UNITED STATES
DEPARTMENT OF THE INTERIOR
BUREAU OF LAND MANAGEMENT

FORM APPROVED
OMB NO. 1004-0135
Expires: July 31, 2010**SUNDRY NOTICES AND REPORTS ON WELLS**
*Do not use this form for proposals to drill or to re-enter an abandoned well. Use form 3160-3 (APD) for such proposals.***SUBMIT IN TRIPLICATE - Other instructions on reverse side.**

1. Type of Well <input checked="" type="checkbox"/> Oil Well <input type="checkbox"/> Gas Well <input type="checkbox"/> Other		5. Lease Serial No. NMNM25365
2. Name of Operator OXY USA INCORPORATED		6. If Indian, Allottee or Tribe Name
Contact: DAVID R STEWART E-Mail: david_stewart@oxy.com		7. If Unit or CA/Agreement, Name and/or No.
3a. Address 5 GREENWAY PLAZA STE 110 HOUSTON, TX 77046-0521	3b. Phone No. (include area code) Ph: 432-685-5717 Fx: 432-685-5742	8. Well Name and No. NEFF 25 FEDERAL 5H
4. Location of Well (Footage, Sec., T., R., M., or Survey Description) Sec 25 T22S R31E NENW 634FNL 2218FWL		9. API Well No. 30-015-41031-00-X1
		10. Field and Pool, or Exploratory LIVINGSTON RIDGE
		11. County or Parish, and State EDDY COUNTY, NM

OXY USA Inc. respectfully requests approval for the following changes to the drilling plan:

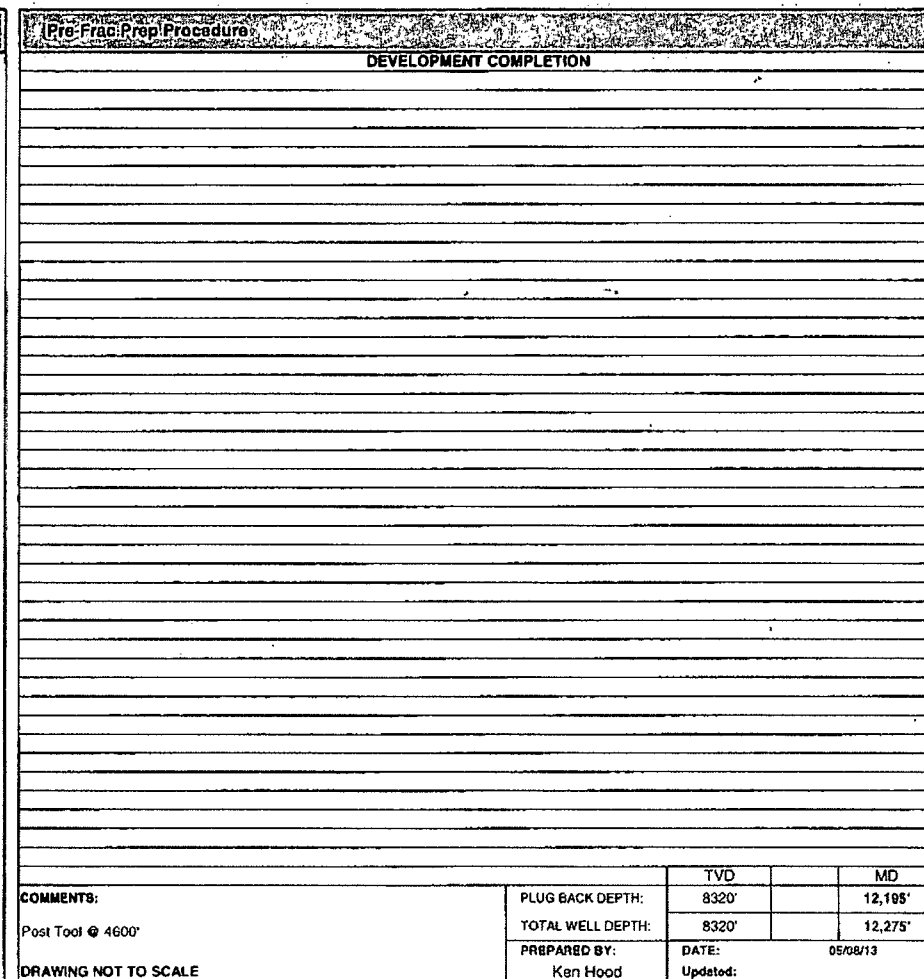
The 5-1/2" casing will be cemented (amended procedure below), but will also have 16 OptiPort Fracturing Sleeves run as an integral part of the casing. These will be made-up to the casing with a pup joint on top and bottom and will be equally spaced between each other in the horizontal section. The Baker Hughes OptiPort is a hydraulically actuated frac port, designed for use in multi-interval stimulation applications. The ports will be run in the closed position. Once the casing has been landed and cemented, a coiled tubing BHA will be deployed into the casing to open the ports individually starting at the toe of the well and moving up hole towards the heel. Each port remains pressure balanced until actuated with the coil BHA and after the port is opened it is locked in the open position allowing for pin point placement of a stimulation treatment.

See below for the revised cementing procedure reflecting the new casing depths as per COA as well as one stage cement job on the production casing instead of three stages. A POST tool will be spaced out below the intermediate casing shoe @ 4600' for contingency 2nd stage, in case cement is not circulated to surface on the primary job.
